ADDENDUM

RFB NO. 322016 - ADDENDUM NO. 1

WALKING IRON WETLAND RESTORATION

WETLAND SCRAPE PLAN VIEW

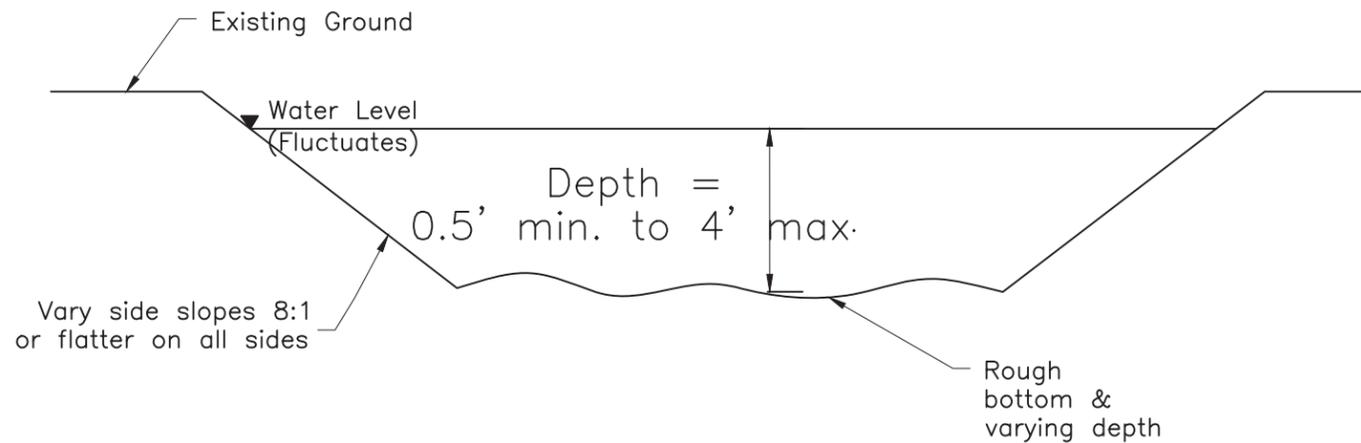
3. Sheet 4 - Scrapes

Delete current Sheet 4 (Scrapes); replace with new Sheet 4 (Scrapes), issued with this Addendum. Scrape #7 has been removed.
